Meadowvale Heritage Conservation District Advisory Sub-Committee

Subject: Request to Alter 1155 Willow Lane

Subject: Request to Alter 1059 Old Derry Road

Subject: Request to Alter 1066 Old Derry Road

Figure 1: Basement plan

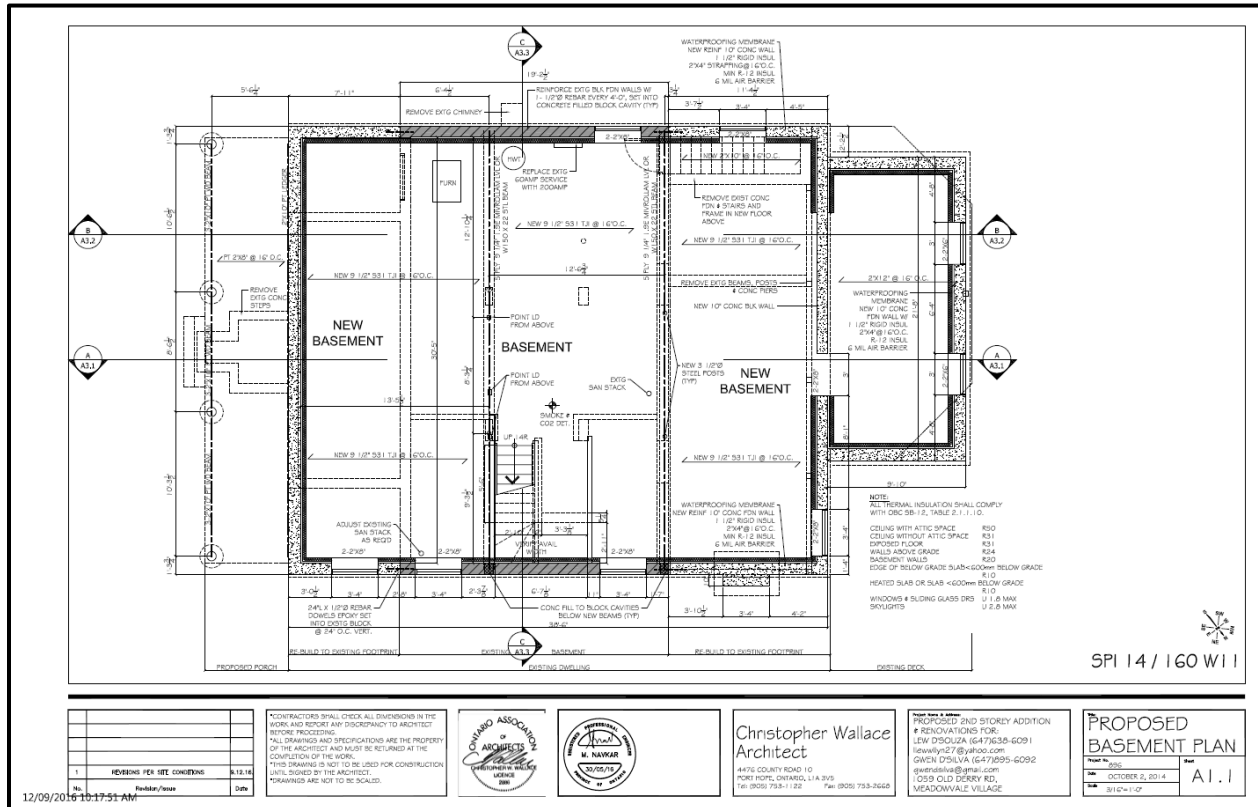
As part of the original designs and permit submitted, it was intended to have a wooden deck in the back of the house. In Aug – 2016, we submitted a revision to this plan. The revised plan proposed a cold room under the backyard deck and a porch at the front of the house without a crawl space. We removed the crawl space from our proposal as we were concerned about the integrity of a very mature tree at the front of the house. (see figure 1)

Figure 2: Top view of basement showing backyard deck plan

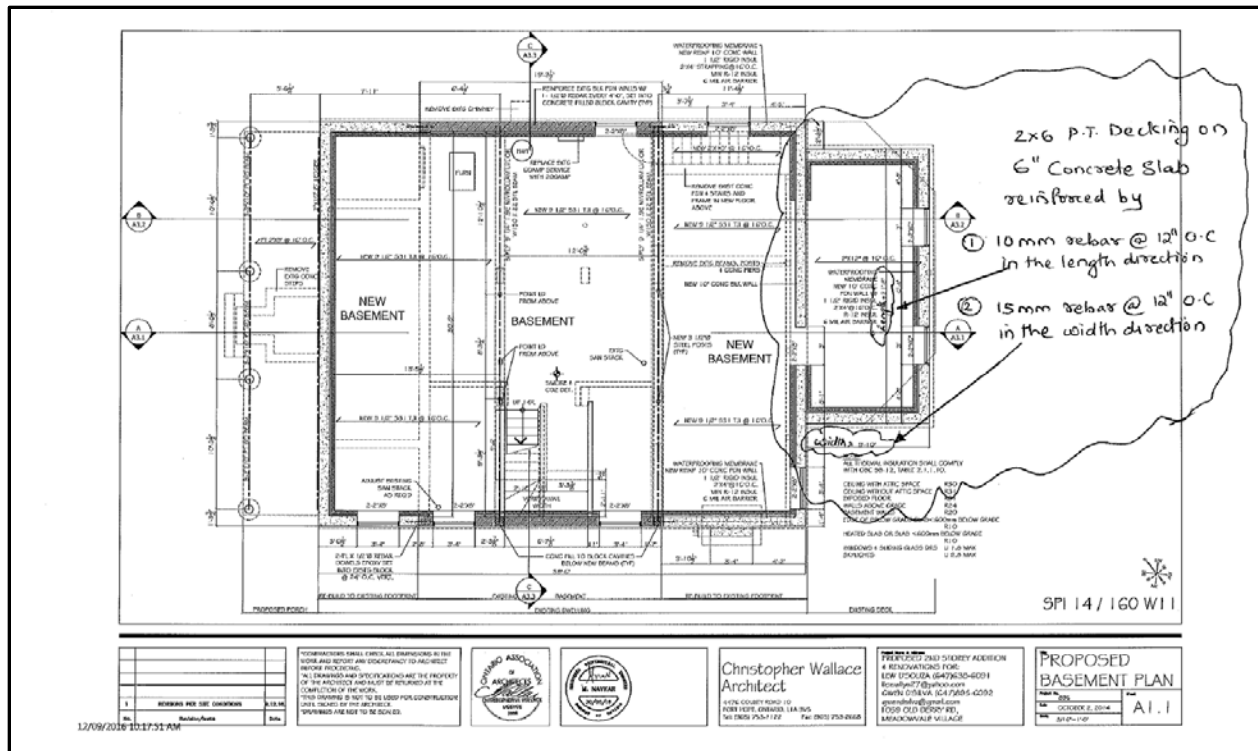
During construction, we were advised that there was a good chance of rain or snow leaking into the cold room below the backyard deck since the deck was without a roof (ex: Pergola, Awning). The contractor recommended a concrete deck. We submitted this change as part of BPA-9896 to the city of Mississauga, Planning & building on Dec 13- 2016. As illustrated in the picture 2 and 3, the proposal was to have a concrete deck that would be cladded with pressure treated decking wood.

My proposal is to leave the concrete deck exposed and not to put any pressure treated wood cladding over the concrete deck. Doing so would be a waste of financial resources and does not add value to the property. Being in the rear of the house and coupled with the fact that the deck is narrower than the width of the house, this deck is not visible from Old Derry road or from the adjacent roads. As the backyard is fenced in, it is impossible for this deck whether it is concrete or wood clad to be visible to neighbors or passerby's. (See Figure 4,5)

That the request to install a concrete deck at the rear of the property at 1059 Old Derry Road, as per the attached drawings, be approved

PRE-CONSTRUCTION PHOTO SHOWING EXISTING ASPHALT DRIVEWAY

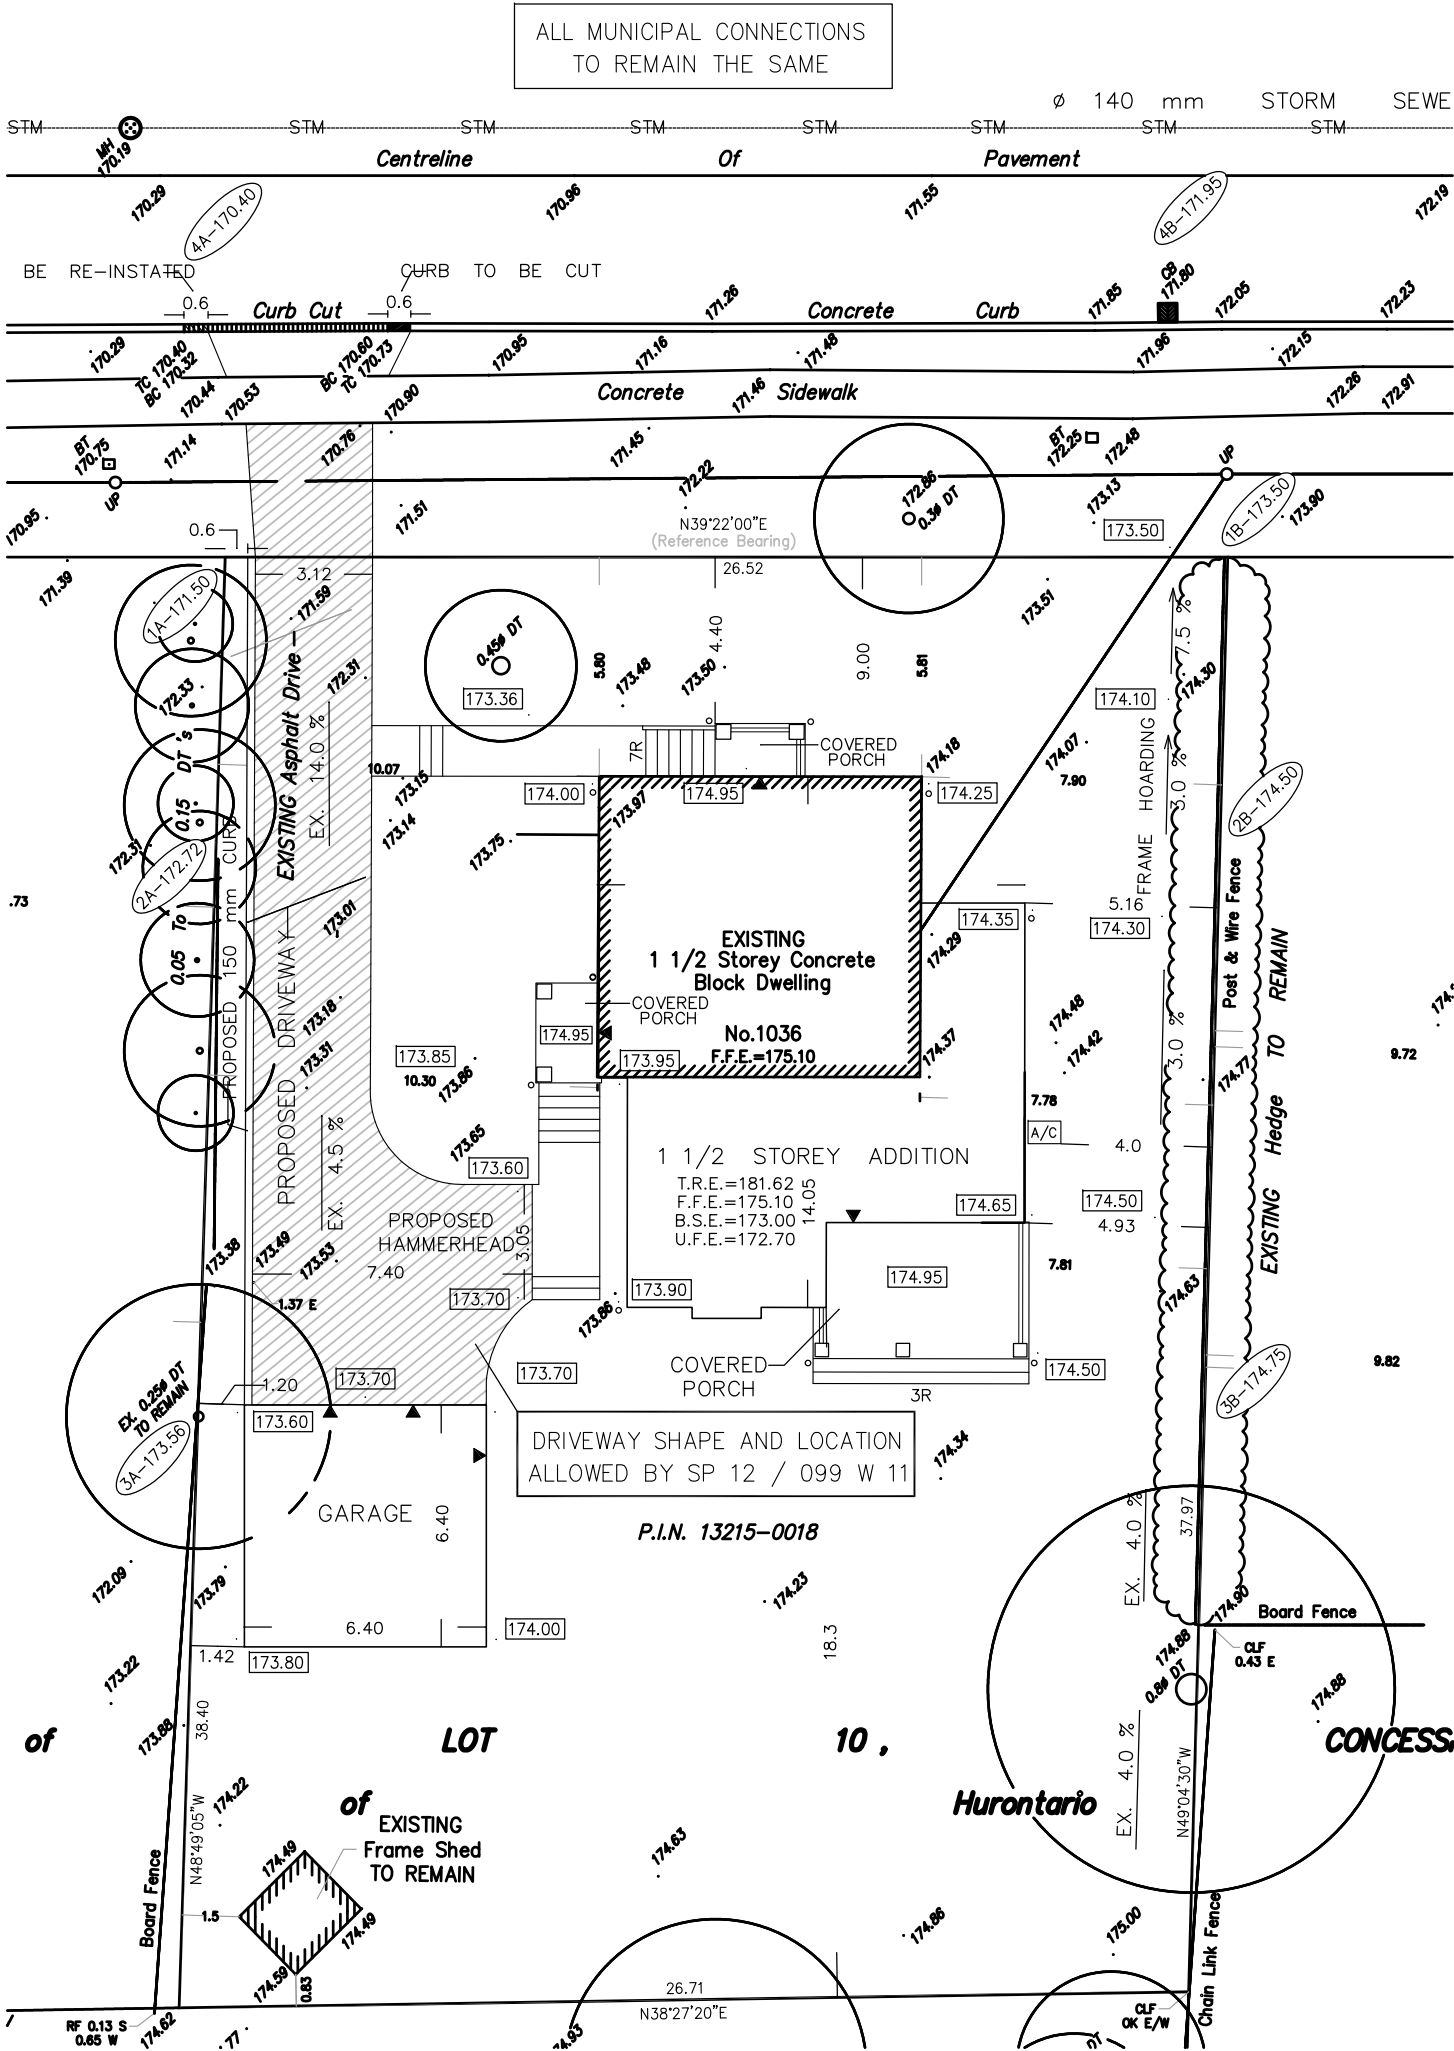
The Meadowvale Village HCD plan stipulates that “permeable paving methods are permitted.” As such, non-permeable paving requires a heritage permit. As per the proponent’s heritage permit application: “The driveway at this residence is steeply inclined and there are safety implications for vehicles and pedestrians.” The driveway is currently gravel and the owner has found it “unsafe to back the vehicle down.” Due to the safety concerns, staff recommend that the asphalt driveway be approved.

That the request to install an asphalt driveway at the property at 1036 Old Derry Road, as per the attached drawing, be approved.

South Elevation | 1/8"=1'-0"
1066 Old Derry Road, Mississauga
November 7, 2017

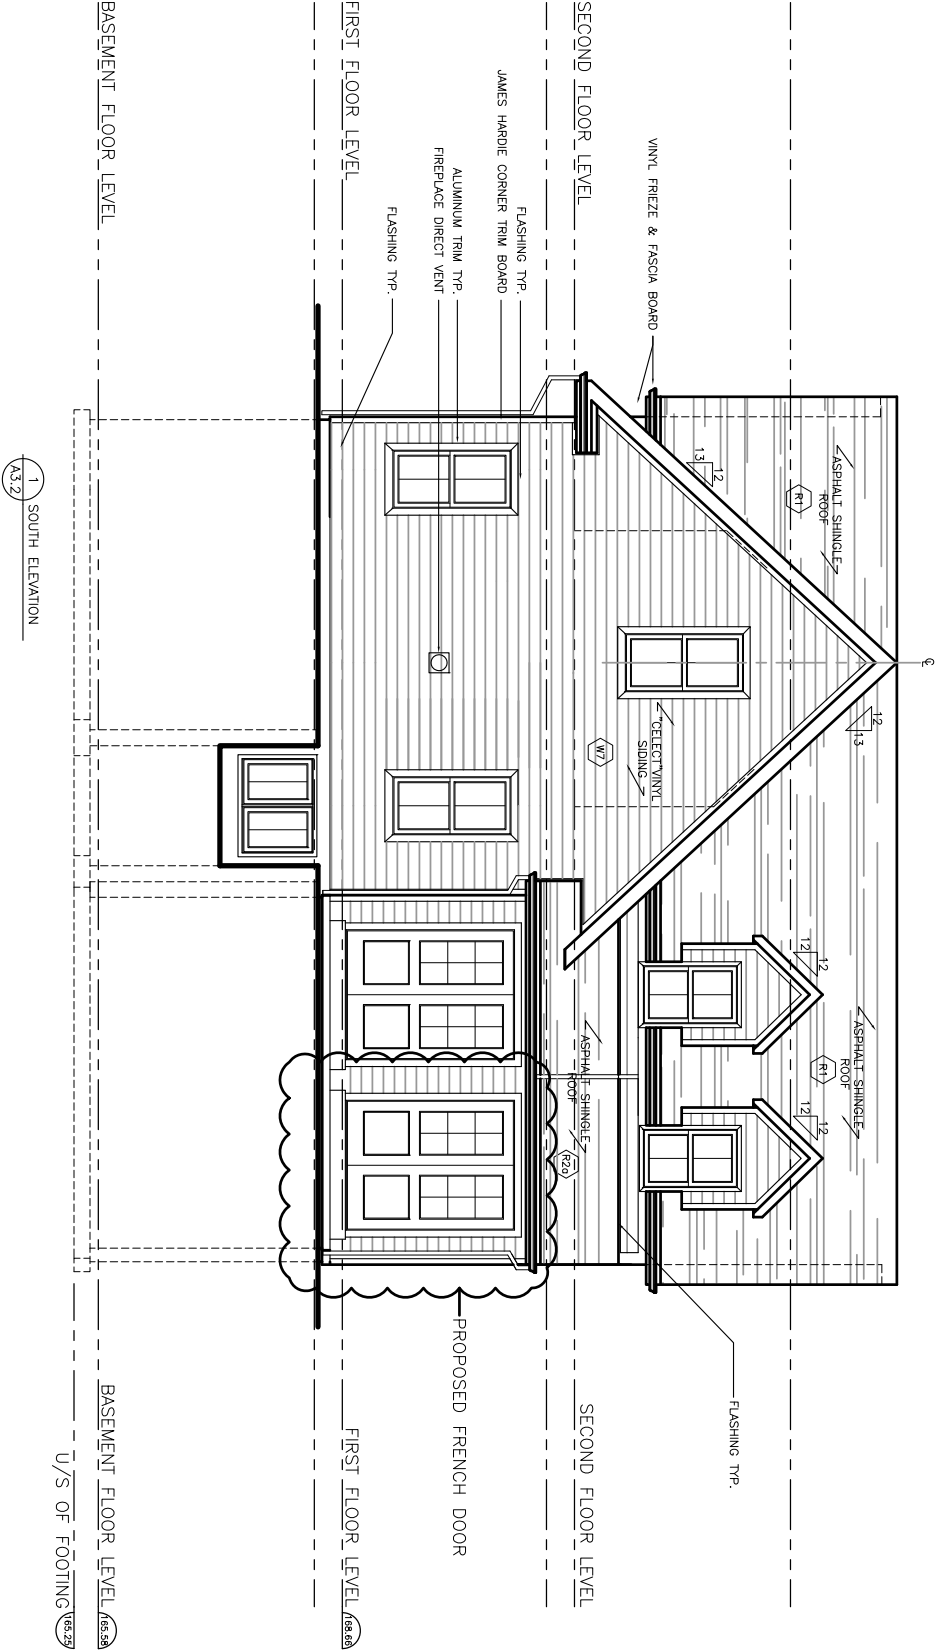
Section 4.2.1.8 of the Meadowvale HCD plan addresses doors. It states that “French doors will be permitted where they cannot be viewed from the public realm.” The subject property backs onto Old Ridge Park and the rear is therefore visible from the public realm. Accordingly, Heritage Planning staff recommend that the application for French doors be refused.

The owner of the subject property requests permission to install French doors at the rear of the dwelling, which is visible from the public realm. Because the plan clearly prohibits this, the request should be refused. The owner of the subject property also requests permission to maintain a modern garage door, which does not match the original approved plans. Because the plan is more ambiguous on this front, the garage door should be approved.

GARAGE DOOR AS INSTALLED

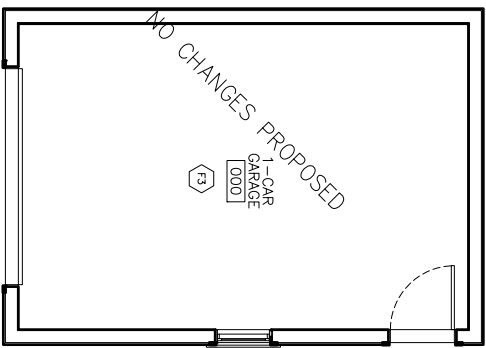
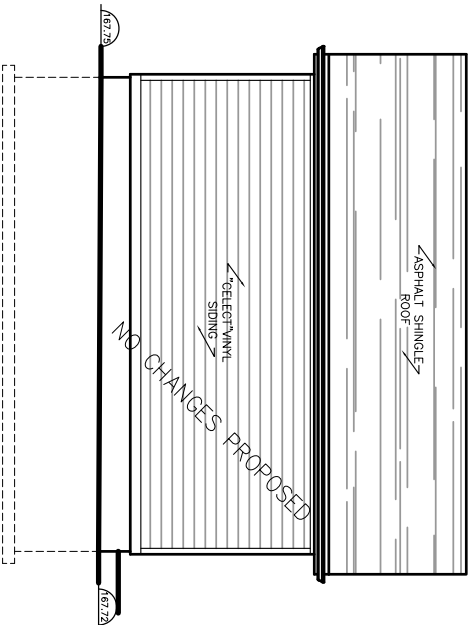
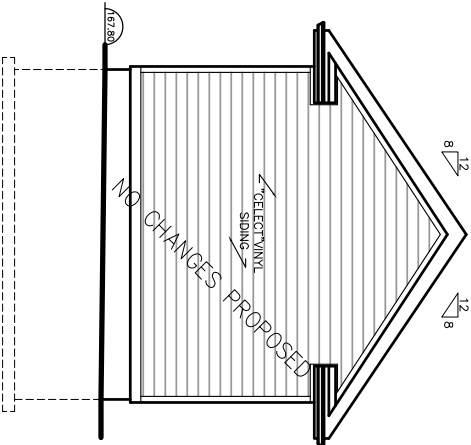
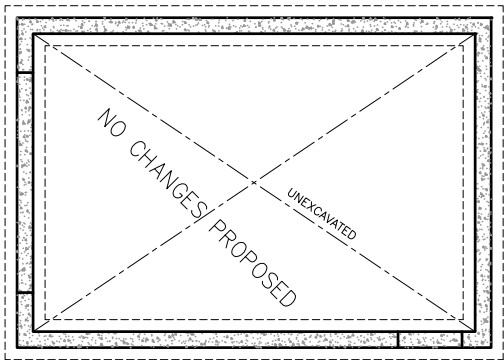
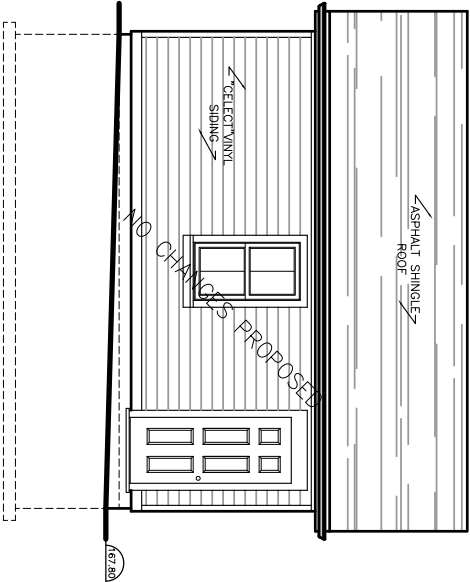
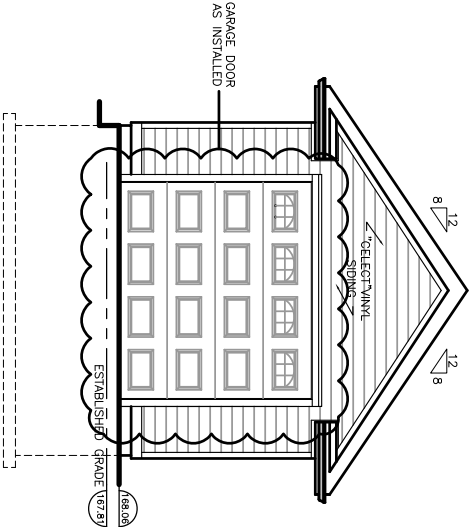
There are no specific guidelines for garage doors. Section 4.2.1.8 applies to existing garages but, presumes that there is an original door to retain or match. Section 4.2.4.2 of the plan speaks to the style of new structures. It states the following:

Overall, the HCD plan emphasizes traditional design. However, the statement above about new construction being "an expression of its own era," suggests that a modern garage door may be acceptable. Because of this, Heritage Planning staff recommend that the modern garage door be approved.
